# Access Compliance Report

## Public Rights-of-Way

### (Pedestrian Signals)

| ADA ID: 1120D8386844                    | Signal Type: One Push Button-APS | Overall Compliance: No                  | Severity Score: BTN 1: N/A BTN 2: N/A No BTN: N/A |

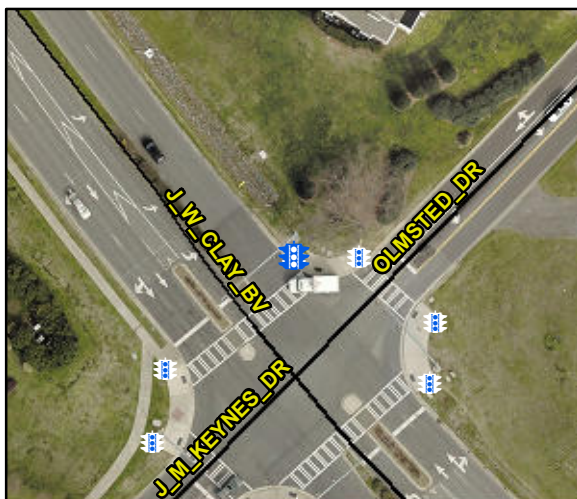
Possible Solutions: Replace Signal Push Button With APS Button on New Post. Remove & Relocate Sign.

PROW/ADA: TMUTCD 4e.08, R404.3, R404.7.3, R404.7.2, MUTCD 4e.08, R104.2, R209.1,
